Technical Information

911 GT3 Cup (991 I & II)

Sicherungsring

Lock ring

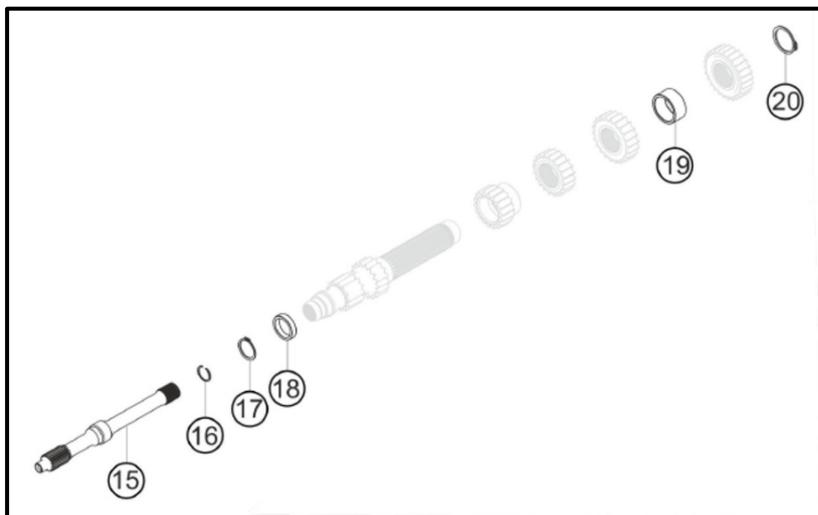
Porsche Motorsport weist darauf hin, dass der Sicherungsring (20) der Getriebe Eingangswelle bei der nächsten Revision des Getriebes zu überprüfen **und** zu wechseln ist.

Bild 1

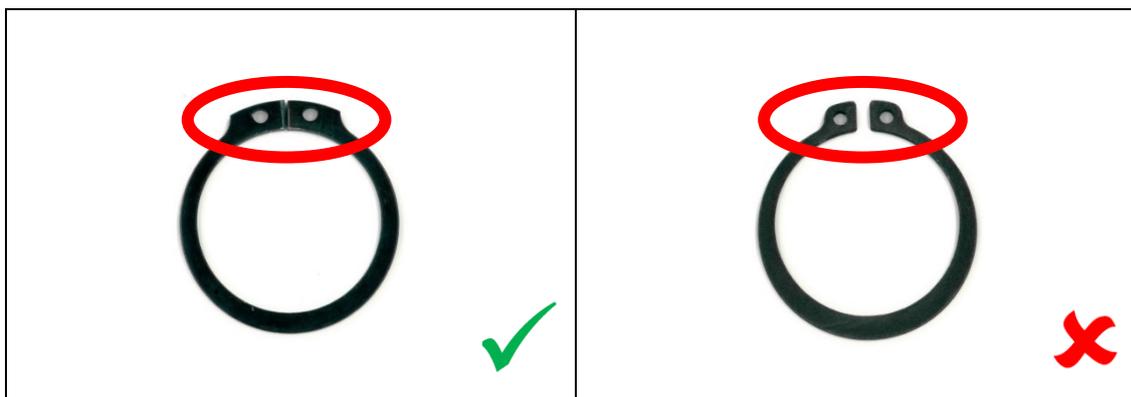
Es muss der Sicherungsring verbaut werden, der der im Bild 1 gezeigten Ausführung entspricht.

1. Teileliste (alter Stand)

Pos	Sachnummer	Bezeichnung	Anzahl pro Fahrzeug
1	900.041.039.01	SI-RING 38X1,75 DIN471 FED-ST B110	1

2. Teileliste (neuer Stand)

Pos	Sachnummer	Bezeichnung	Anzahl pro Fahrzeug
1	991.302.191.9A	SICHERUNGSRING	1

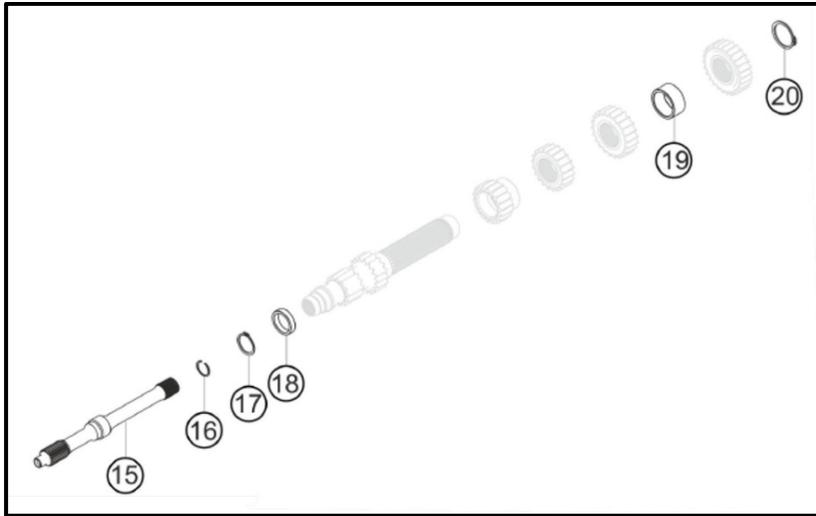
Porsche Motorsport informs that the circlip (20) on the gearbox input shaft **MUST** be checked **and** replaced during the next gearbox rebuild.

Image 1

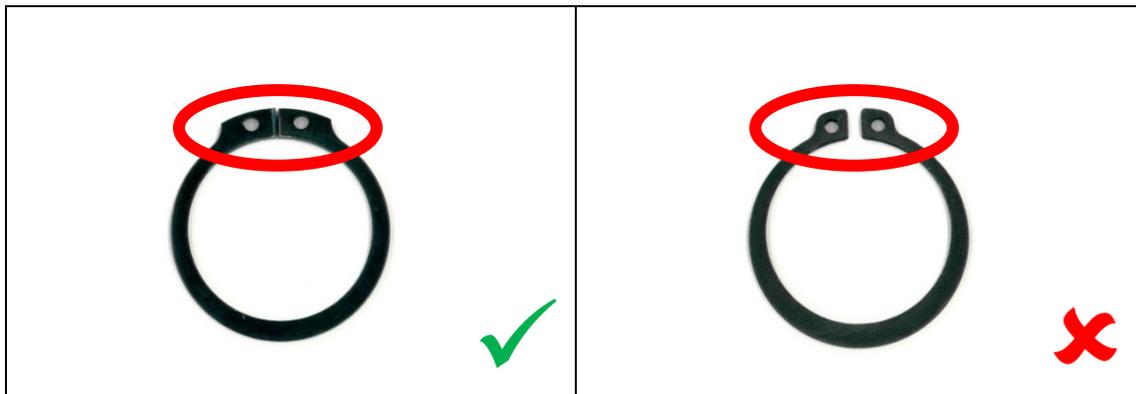
The type of circlip shown in image 1 must be fitted.

1. Parts list (old assembly)

Pos	Part number	Name	Pieces per car
1	900.041.039.01	LOCK RING 38X1,75 DIN471 FED-ST B110	1

2. Parts list (new version)

Pos	Part number	Name	Pieces per car
1	991.302.191.9A	LOCK RING (CIRCLIP)	1
